October 12, 2001

Re: Supplemental Comments of General Electric Company on the Feasibility Study and Proposed Plan for the Hudson River PCBs Superfund Site

Cumulative Load (2004-2035) to the Lower Hudson River - GE Model

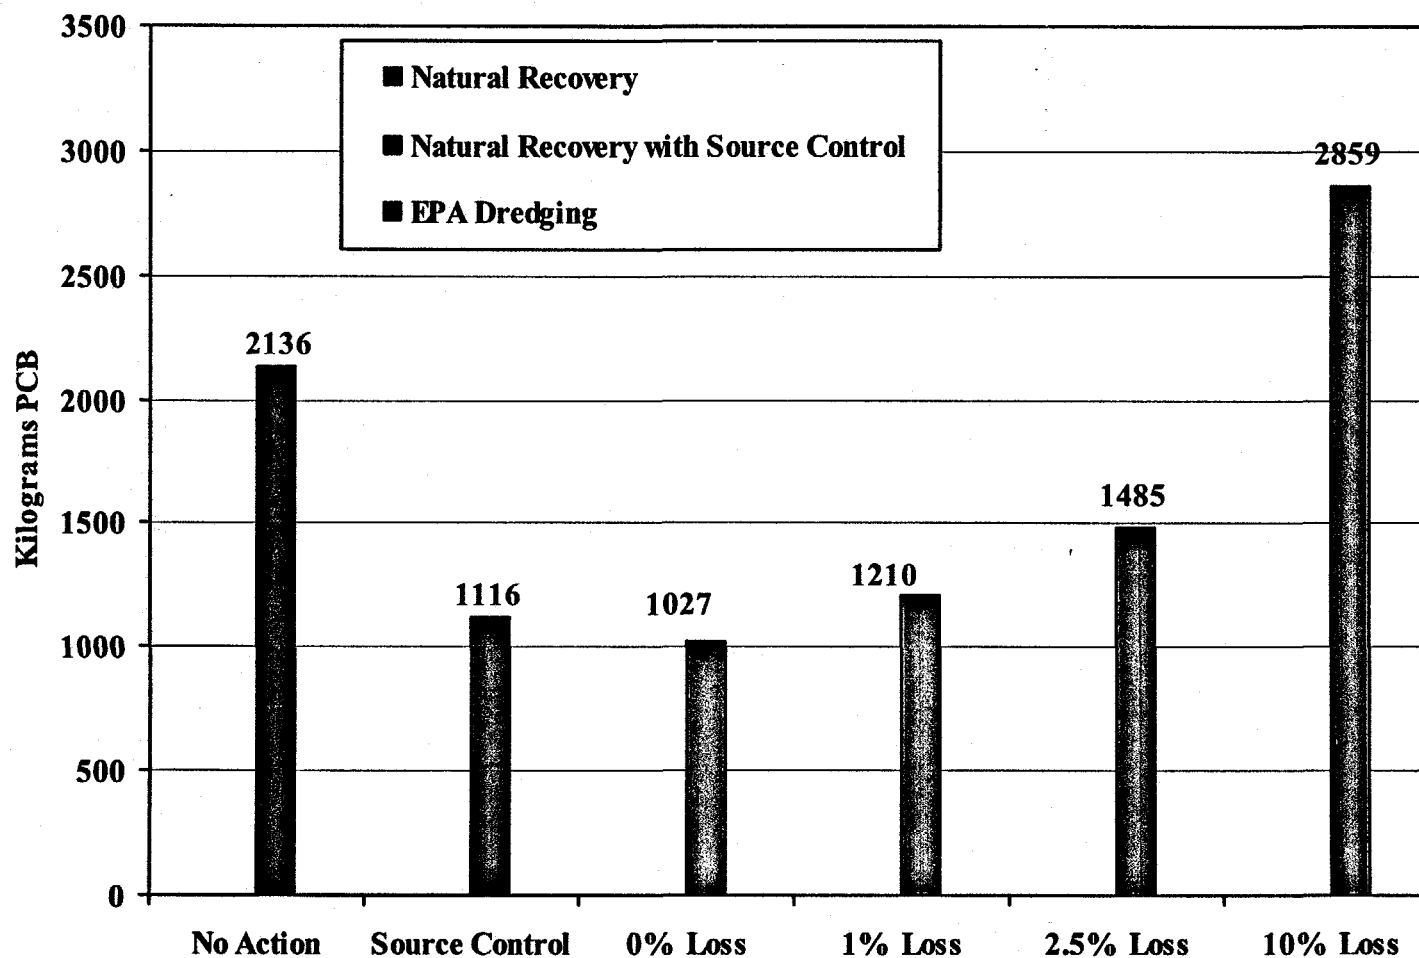
Note that EPA dredging dredging plan uses realistic assumptions (duration of 10 years and no backfilling navigational channel). Percent PCB₃₊ loss is indicated by x-axis label. PCB release via resuspension based on tri+ mass targeted for dredging.

Species-Weighted PCB Concentrations in Fish from Thompson Island Dam to Northumberland Dam
(Section 2) Projected Under Natural Recovery with and without Source Control and Dredging Scenarios

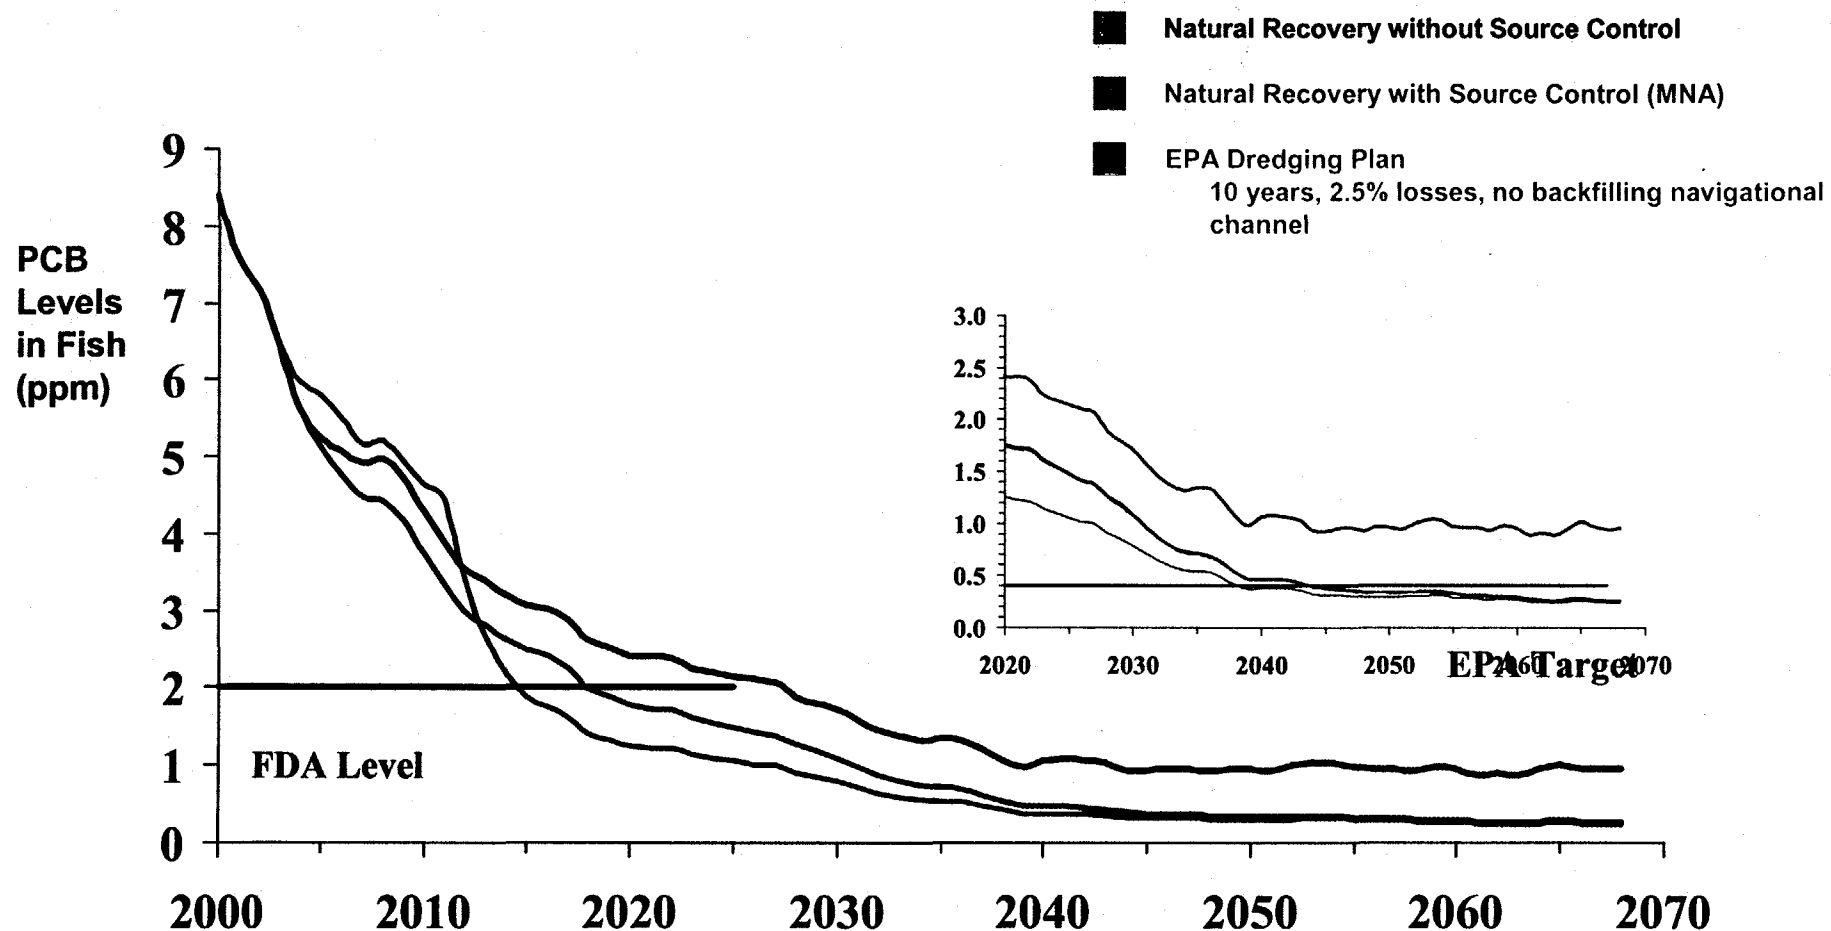
Assuming Dredging Releases 2.5% of PCBs & EPA Plan Takes 10 Years:

Note that PCB release via resuspension based on tri+ mass targeted for dredging.

Species-Weighted PCB Concentrations in Fish from Northumberland Dam to Troy Dam (Section 3)
Projected Under Natural Recovery with and without Source Control and Dredging Scenarios

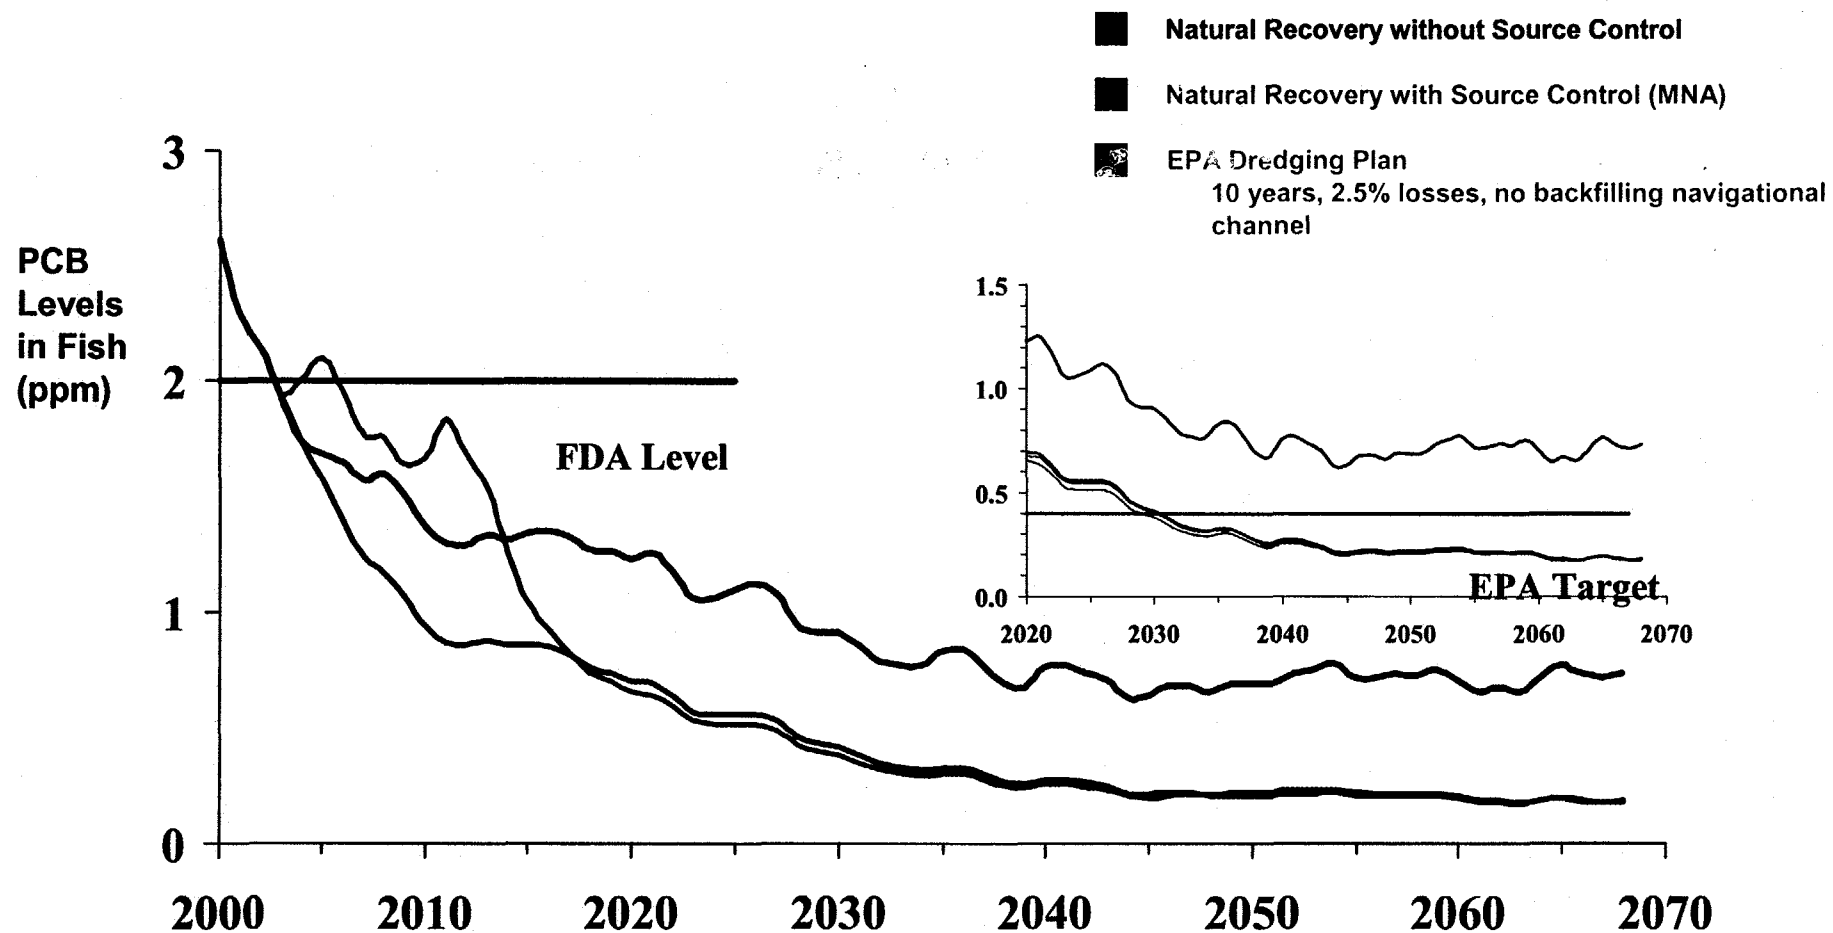
Assuming Dredging Releases 2.5% of PCBs & EPA Plan Takes 10 Years:

Note that PCB release via resuspension based on tri+ mass targeted for dredging.

Cumulative Load (2004-2035) to the Lower Hudson River - EPA Model

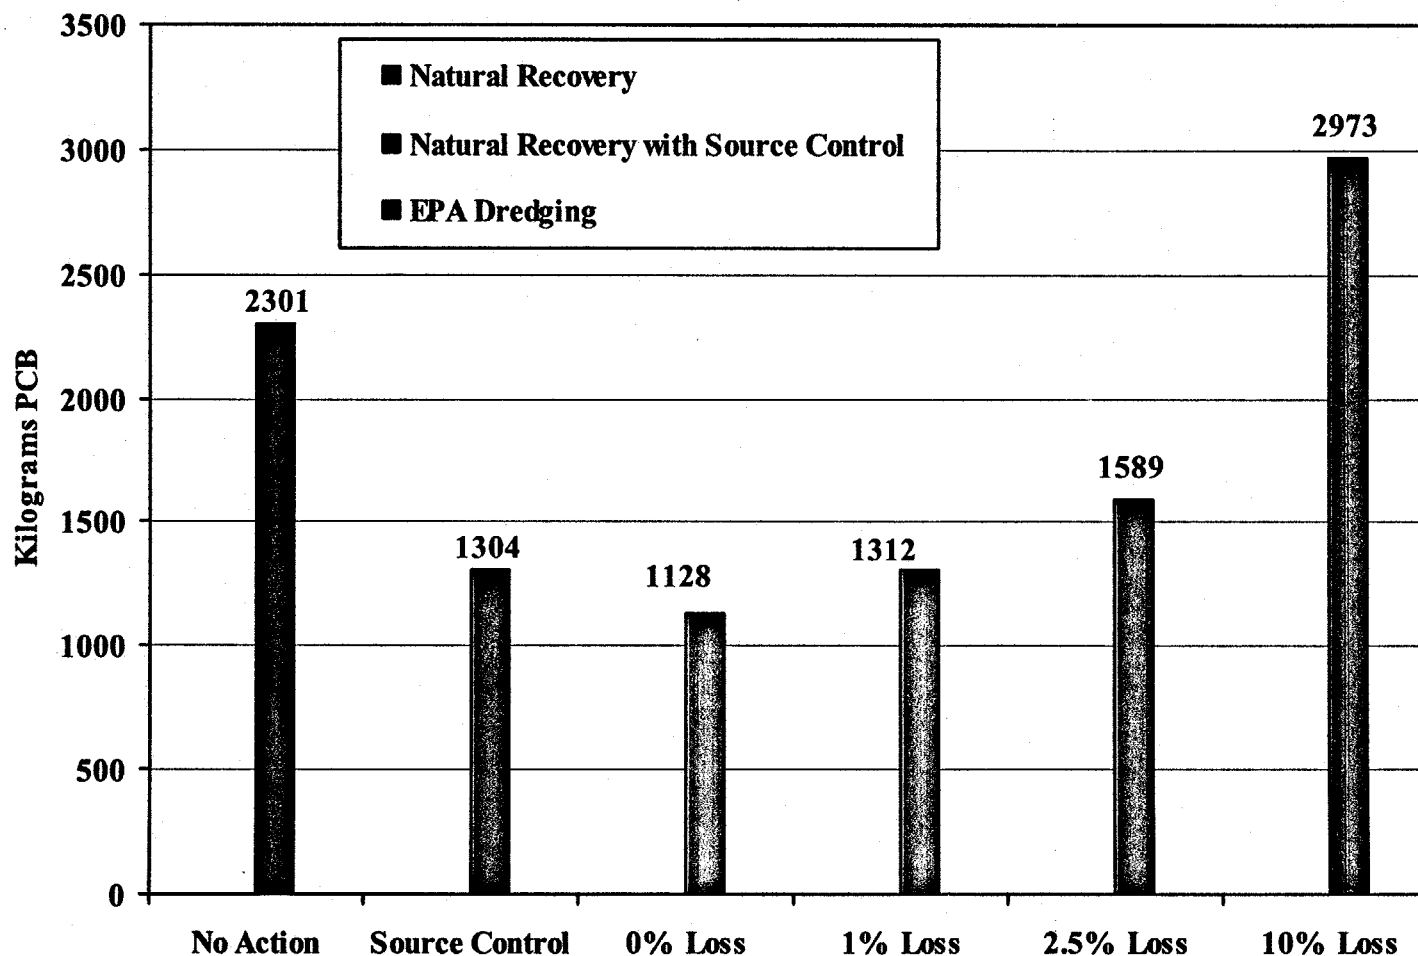
Note that EPA dredging dredging plan uses realistic assumptions (duration of 10 years and no backfilling navigational channel). Percent PCB₃₊ loss is indicated by x-axis label. PCB release via resuspension based on tri+ mass targeted for dredging.

**Species-Weighted PCB Concentrations in Fish from Thompson Island Dam to Northumberland Dam
(Section 2) Projected Under Natural Recovery with and without Source Control and Dredging Scenarios**

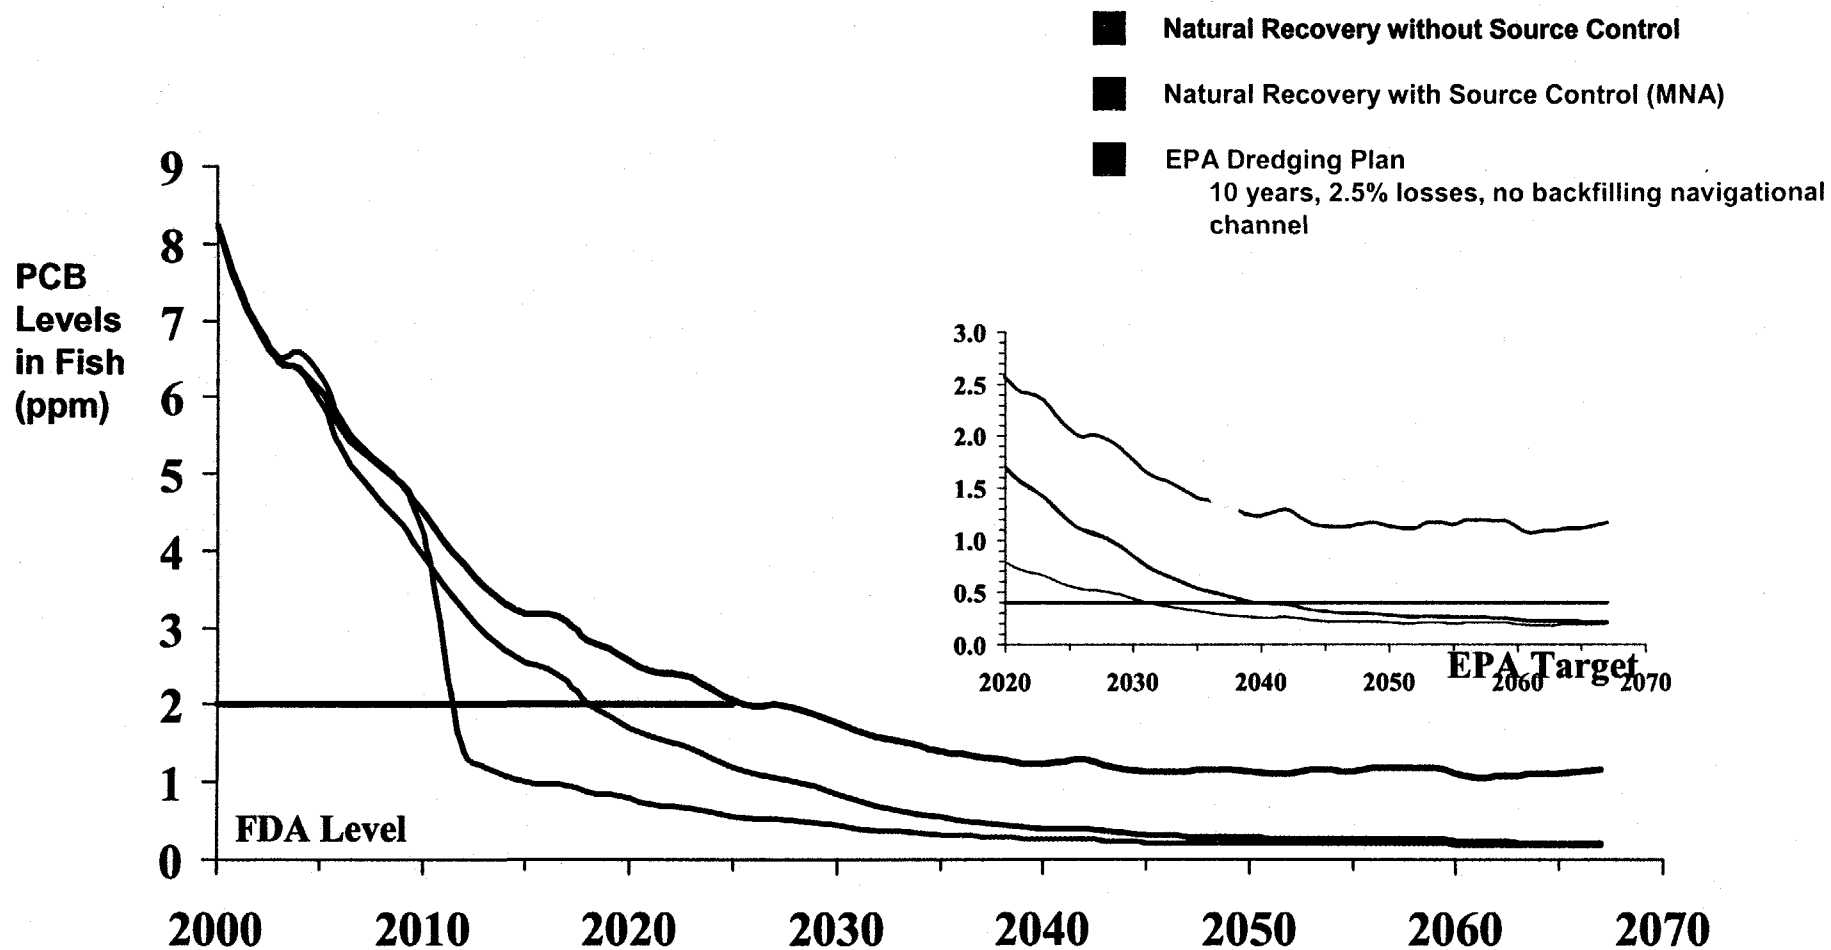
Assuming Dredging Releases 2.5% of PCBs & EPA Plan Takes 10 Years:

Note that PCB release via resuspension based on tri+ mass targeted for dredging.
